Safety Evaluation Report

SPENT FUEL STORAGE

OCONEE SPENT FUEL

McGUIRE NUCLEAR STATION - UNIT 1

FIG. 4-1 Onsite Route Traveled by spent fuel cask

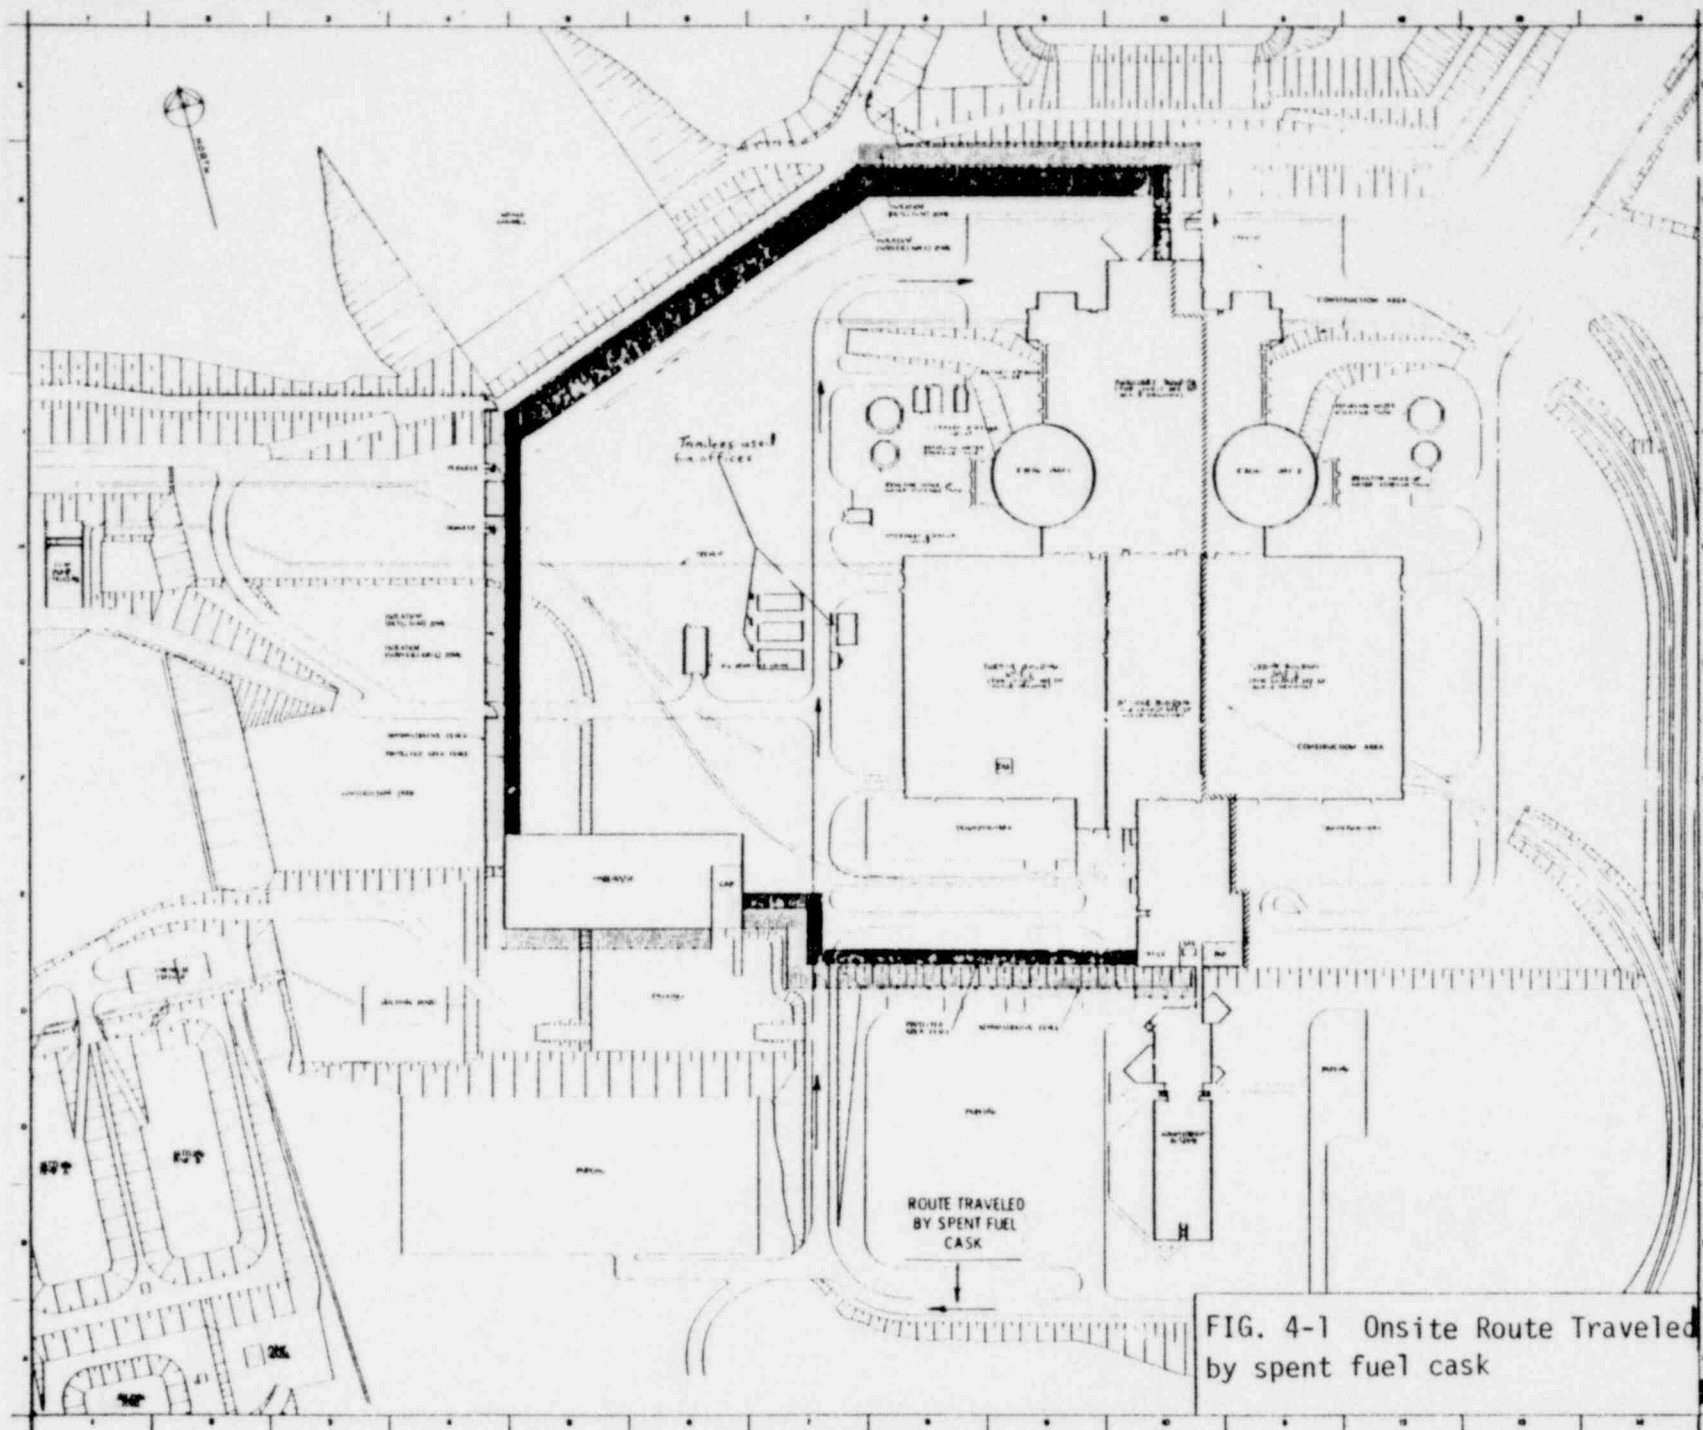
At the McGuire site, the shipment will enter the Duke Power Company road off of N.C. Route 73, travelling 0.5 Km (0.3 mi.) then pass through the split parking lot and stop at the Security Gate to gain admission to the Station protected area. The shipment would then move directly north past the warehouse, turbine building, four trailers used as temporary offices, then turn east to the north end of the auxiliary building where the spent fuel storage pool is located. See Figure 4-1.

- Administration Building - About 100 employees work in the Administration Building, a corner of which is 100 meters (325 feet) from the nearest passage of the shipment as it enters the station. It is conceivable that some employees could be in the parking lot as the truck passes through some 10 meters (30 feet) away.

- Security Gate - Two or more guards will be located at the Security Gate where the shipment and drivers will be checked before being permitted to enter the Protected Area. This is estimated to take about 10 minutes, during which time the guards could remain in the vicinity of the cask.

- Temporary Offices - Four trailers serving as temporary offices for about 60 Station personnel are located as near as 6 meters (20 feet) from the route of the cask as it heads toward the spent fuel storage area.

- Turbine Building - The nearest side of the Turbine Building where construction activities will be essentially complete is 20 meters (65 feet) from the route of the cask.

- Construction Areas - Construction will be continued during the transshipment activities, but only at Unit 2. A system of security fences and gates, patrolling and posted guards, existing walls, temporary barriers, and alarms will be used to prevent unauthorized access of the construction force into Unit 1 operating areas, including the spent fuel storage pool area and yard. The nearest point of unshielded access to the

parked cask is at the East Security Gate, about 60 meters (200 feet) away. Other points may be equidistant but are shielded by concrete walls and/or earthen berm. Duke Power Company has indicated that any construction/vendor personnel who must gain access to any area where there would be exposure above background doses will be under direct supervision of the McGuire Health Physicist. The temporary barrier system described by the Applicant and which is part of the Security Plan has been reviewed by the staff and found acceptable.
